## Final MYO Monitoring Report

Owen Farms Mitigation Site  
Transylvania County, NC

NCDMS Project No. 100064  
NCDMS Contract No. 7532  
NCDMS RFP No. 16-007334  
(Issued 9/8/2017)

Re: MY0 As-Built Baseline Monitoring Report Comments  
Owen Farms Stream and Wetland Mitigation Site  
French Broad River Basin; CU# 06010105 – Transylvania County  
DMS Project ID No. 100064  
Contract No. 7532

### Figure 4.12 UT 7 - Longitudinal Profile

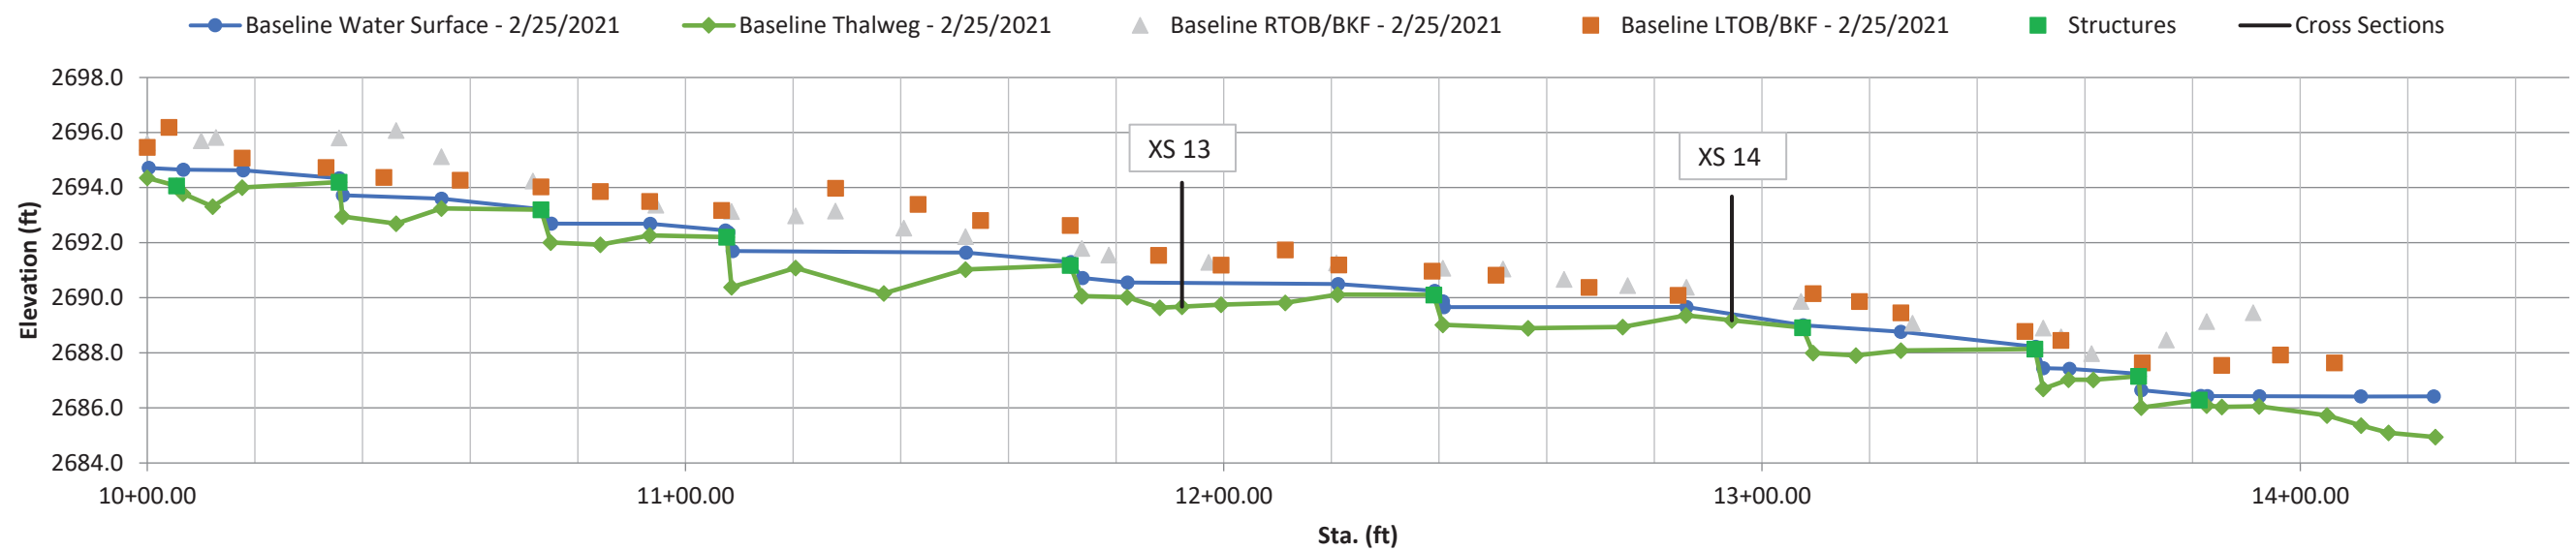
23. It looks like the profile figure for UT7 was not included in the report but was included in the profiles and cross sections spreadsheet. Please update as necessary.

*RE: Comply. The UT 7 longitudinal profile is now included as Figure 4.12.*

*RE: Comply. The profile figure for UT 7 has been included in the report.*
